# Regional Review Finding Development of Regional Impact

**RE:** Development of Regional Impact (DRI) Review

**Name of Proposal:** Project Rockforge DRI 4456

**Description:** A DRI review of a proposal to build 4,089,000 SF of data center space in eight two-story buildings on 263-acre mostly forested site traversed by several streams at the SW corner of the intersection of Irwin Bridge Road and Farmer Road in Rockdale County.

**CONCEPTUAL SITE PLAN**  
**SHEET CP-1**

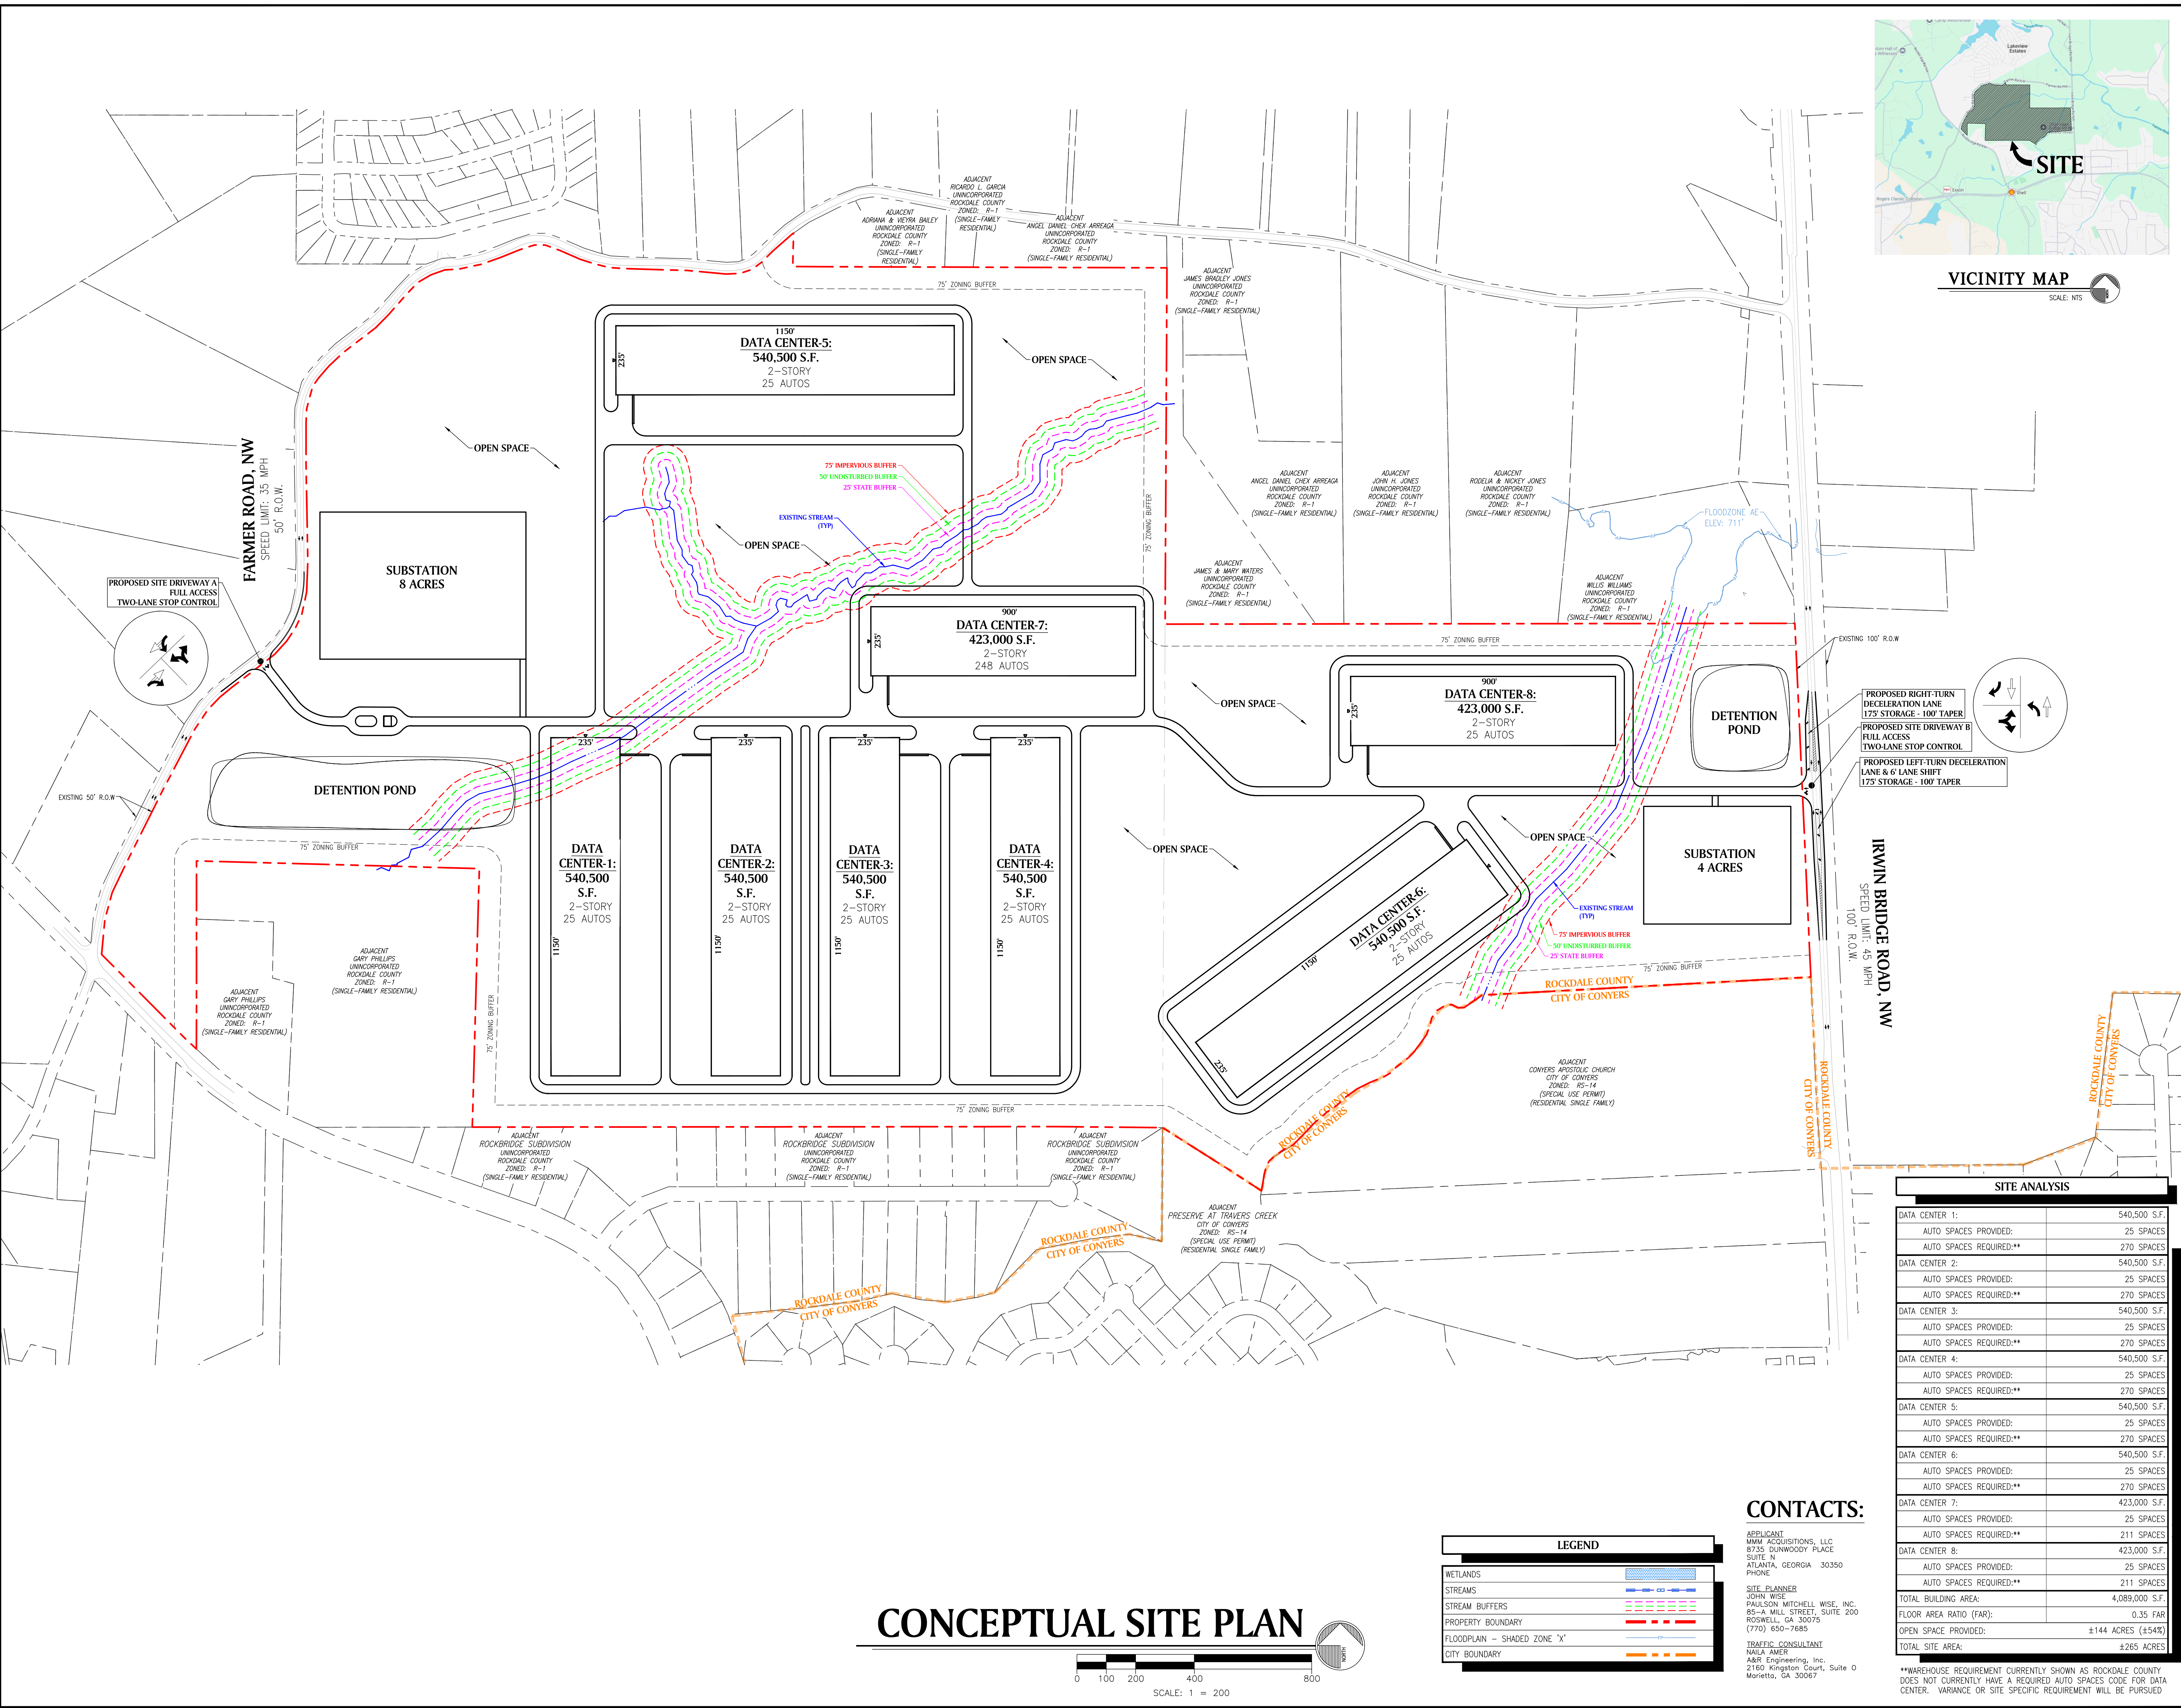
The USGS coverage for the project area and the submitted site plan both show two blue-line tributaries to the Yellow River crossing the project property. The project site plan also shows a short branch off the northwesternmost of the two mapped tributaries. The submitted site plan shows and identifies the 25-foot State Sediment and Erosion Control Buffer as well as the Rockdale County 50-foot undisturbed buffer and the 75-foot impervious setback on all indicated streams. The submitted site plan shows portions of a detention pond, Data Center 1, access roads, driveways and parking areas intruding on the buffers or directly over the streams. While some transportation crossings are exempt under the County ordinance, other activities and intrusions that are not specifically exempted in the County buffer and setback may require variances from Rockdale County and intrusions that are not exempted in the State 25-foot buffer may require variances from Georgia EPD. Any unmapped streams on the property may also be subject to the County buffer requirements. Any unmapped State waters identified on the property may also be subject to the State 25-foot Sediment and Erosion Control buffer.

Both the FEMA coverage for the project area and the project site plan show a small area of 100 -year floodplain along the easternmost blue-line stream in the northeastern portion of the property. The floodplain area on the site plan is entirely within the stream buffers and no intrusions are shown.

The project's provision of 144 acres of open space is supportive of regional environmental policies. However, the project's negative impacts on several streams is not supportive of regional environmental policies. The project could be made more supportive of regional environmental policies by reducing stream impacts. Incorporation of green stormwater and heat island mitigation designs - such as the provision of numerous curbside tree islands in parking areas - where possible would be supportive of regional environmental policies. The project can support The Atlanta Region's Plan in general by incorporating other aspects of regional policy, including green infrastructure and/or low-impact design, e.g., pervious pavers, rain gardens, vegetated swales, etc., in parking areas and site driveways, and as part of any improvements to site frontages.

The USGS coverage for the project area and the submitted site plan both show two blue-line tributaries to the Yellow River crossing the project property. The project site plan also shows a short branch off the northwesternmost of the two mapped tributaries. The submitted site plan shows and identifies the 25-foot State Sediment and Erosion Control Buffer as well as the Rockdale County 50-foot undisturbed buffer and the 75-foot impervious setback on all indicated streams. The submitted site plan shows portions of a detention pond, Data Center 1, access roads, driveways and parking areas intruding on the buffers or directly over the streams. While some transportation crossings are exempt under the County ordinance, other activities and intrusions that are not specifically exempted in the County buffer and setback may require variances from Rockdale County and intrusions that are not exempted in the State 25-foot buffer may require variances from Georgia EPD.

Any unmapped streams on the property may also be subject to the County buffer requirements. Any unmapped State waters identified on the property may also be subject to the State 25-foot Sediment and Erosion Control buffer.

Both the FEMA coverage for the project area and the project site plan show a small area of 100 -year floodplain along the easternmost blue-line stream in the northeastern portion of the property. The floodplain area on the site plan is entirely within the stream buffers and no intrusions are shown.
